ADDENDUM NO. TWO (2)
TOWN OF BRASELTON, GEORGIA
2026 GROUNDWATER EXPANSION AND DISTRIBUTION STORAGE
ISSUED JANUARY 23, 2026

RE: 2026 GROUNDWATER EXPANSION AND DISTRIBUTION STORAGE
EMI PROJECT No. 18-021

The purpose of this Addendum is to provide the omitted storage tank drawings, existing contours for treatment site, the pre-bid meeting attendance, and add Precon Corporation as a pre-approved concrete storage tank manufacturer. The following items of the Contract Documents are modified as part of this Addendum:

PLAN

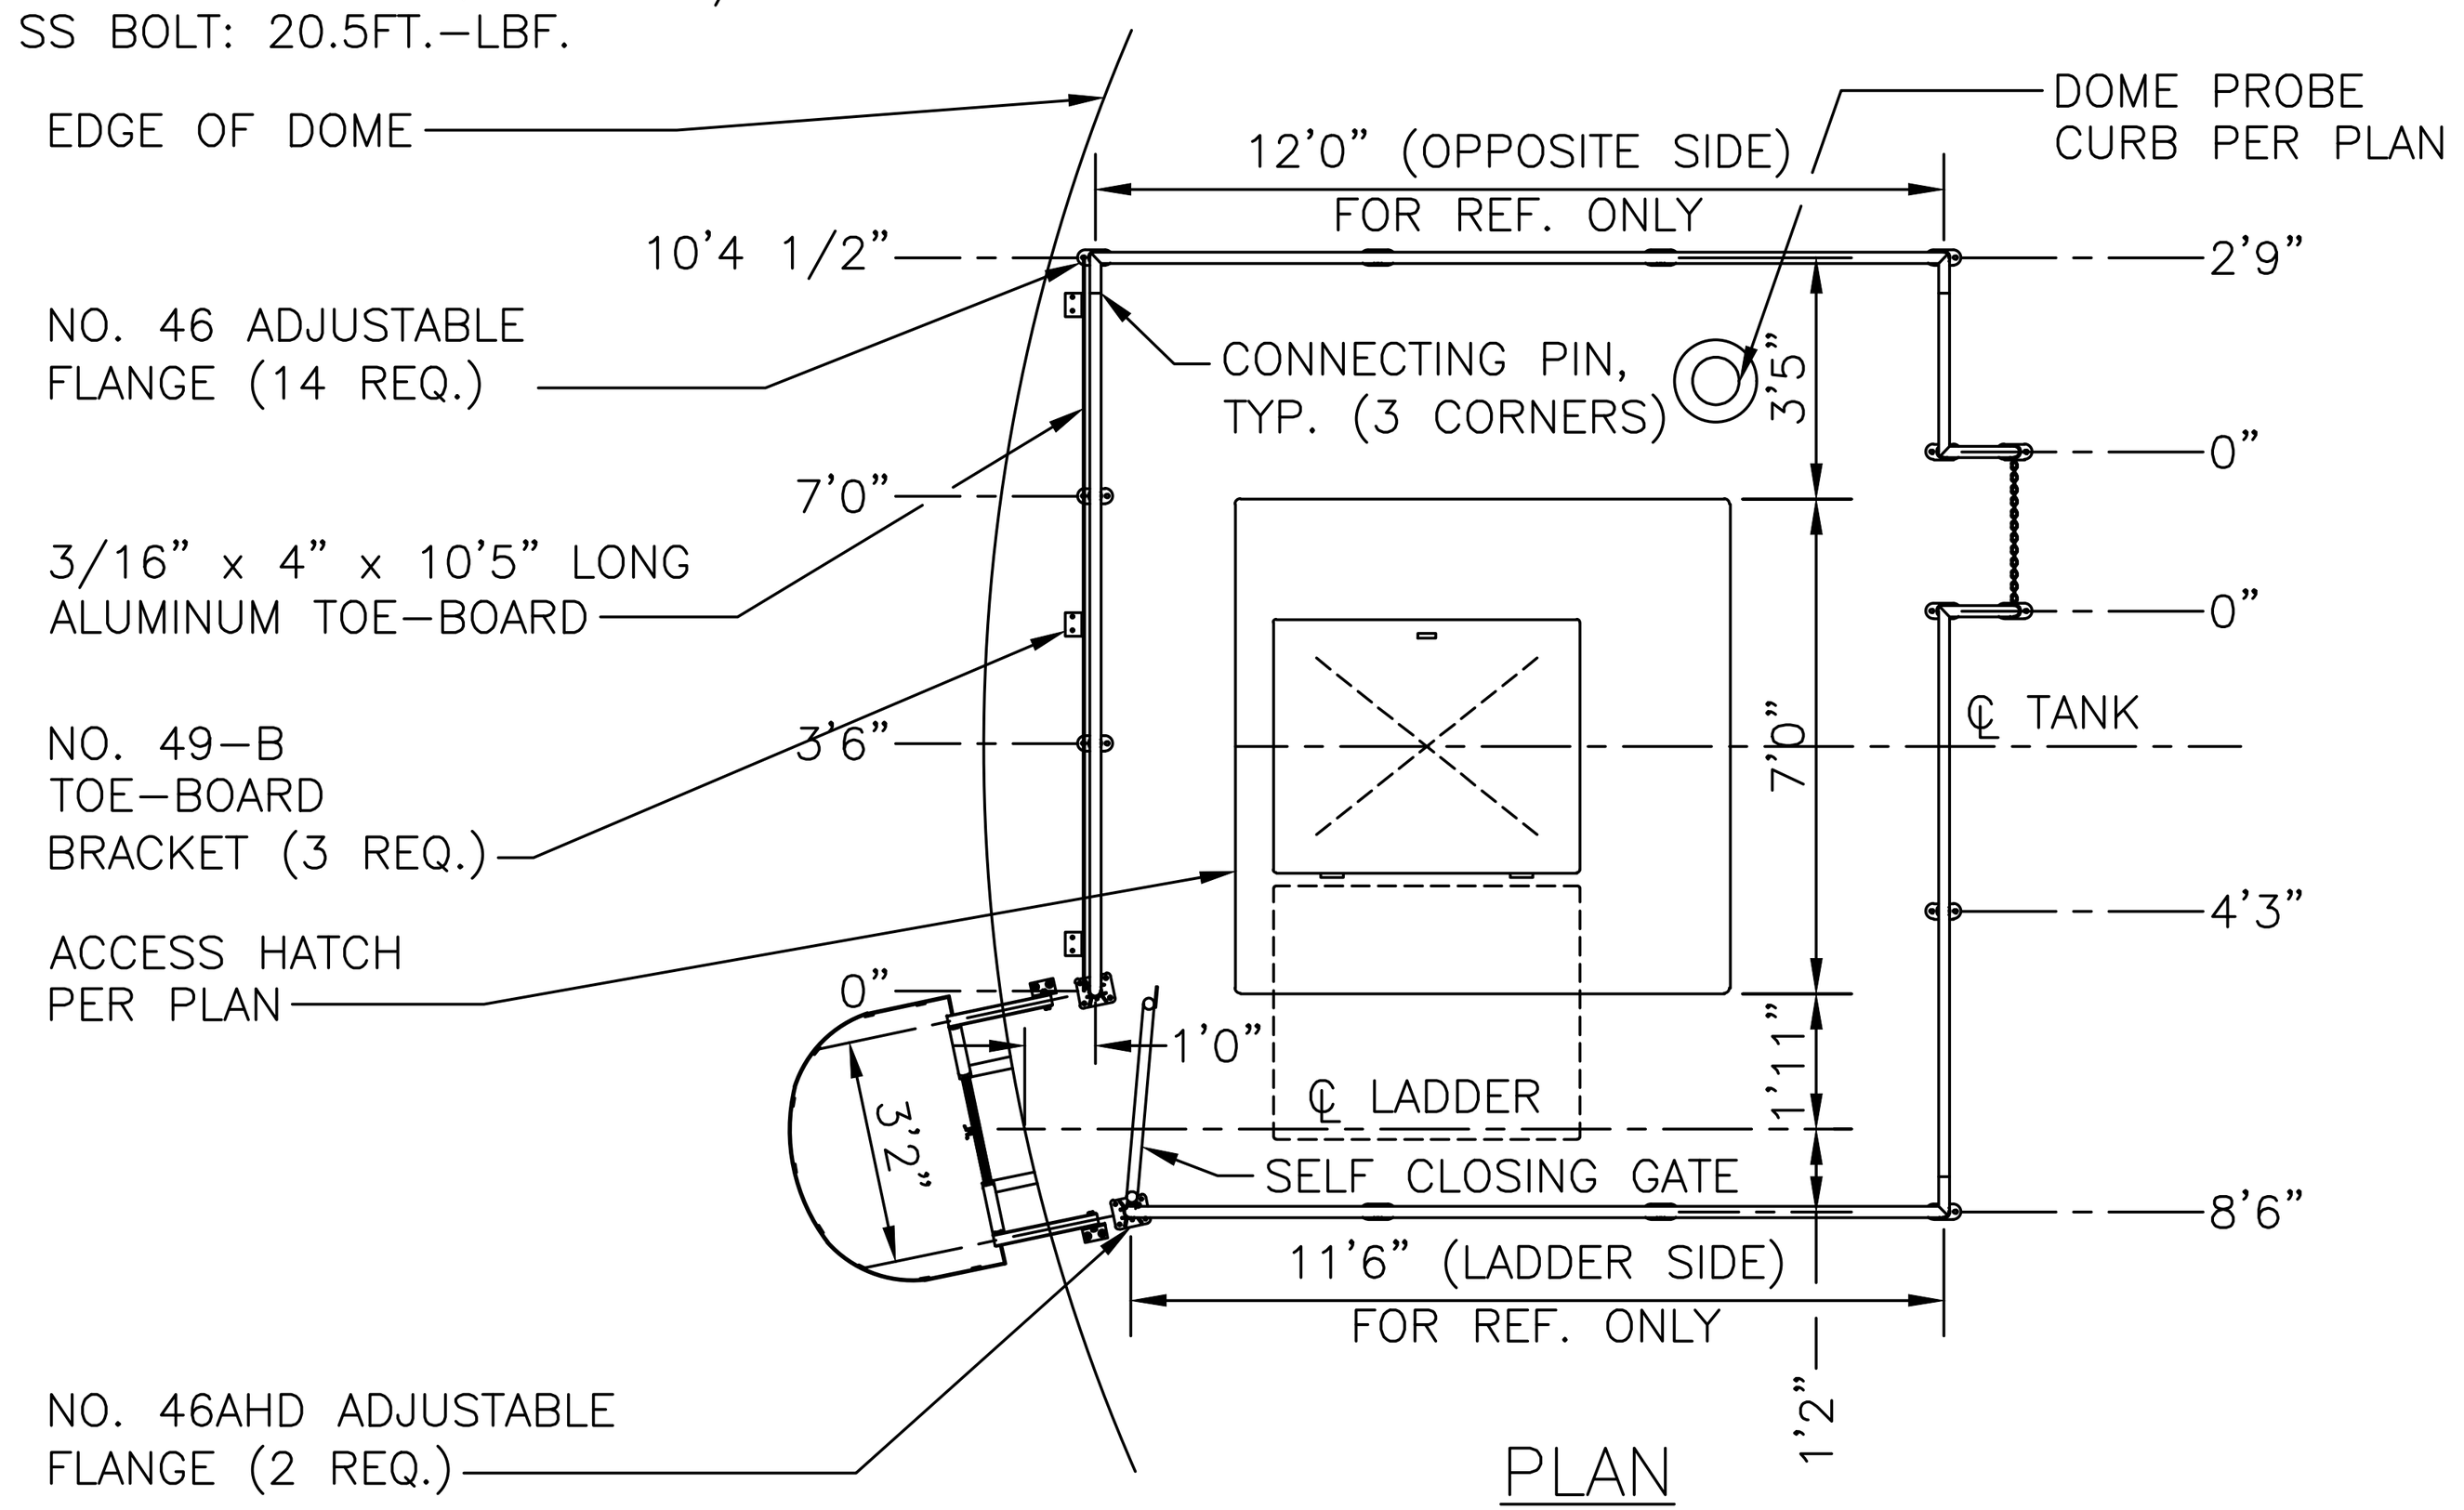
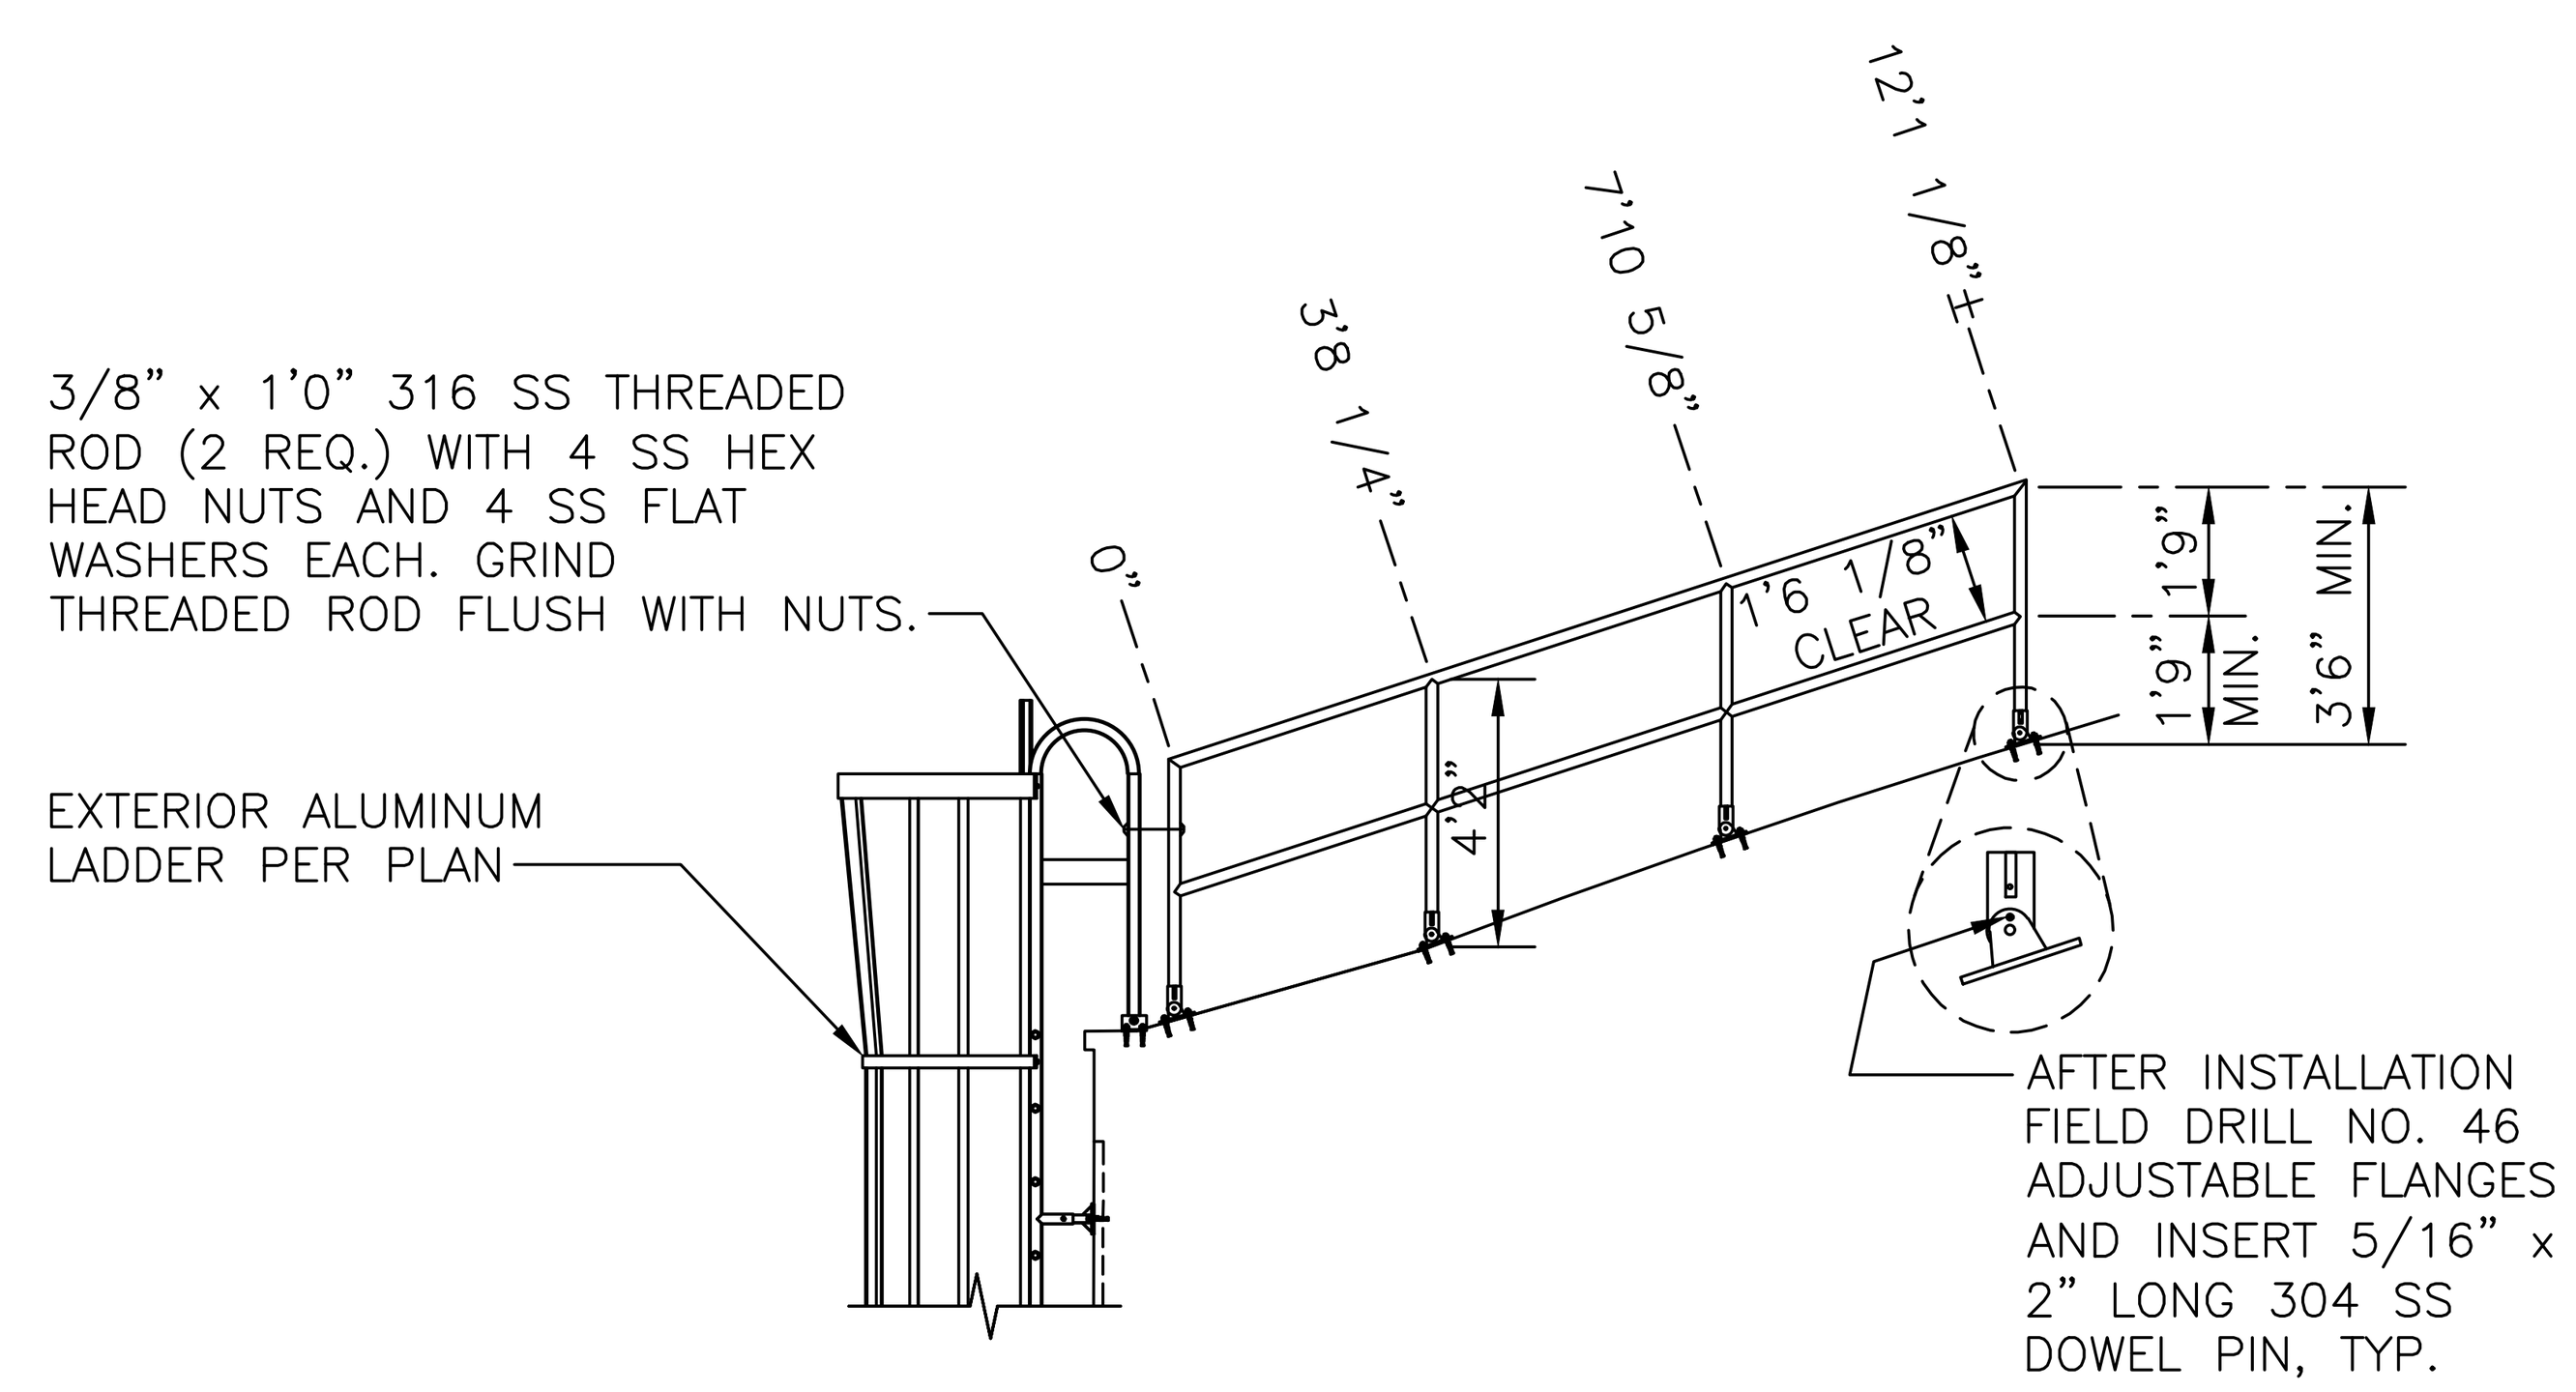
1. The contract documents appear to be missing plan sheets M7-M10 for the new tank listed in the sheet index. Can you please provide the missing drawings?

- <u>*Plan sheets M7-M10 have been provided to show plans for the concrete storage tank. See attached plan sheets.*</u>

EMI Response: Sheets M7-M10 were omitted in error. Please see the original sheets attached to this addendum.
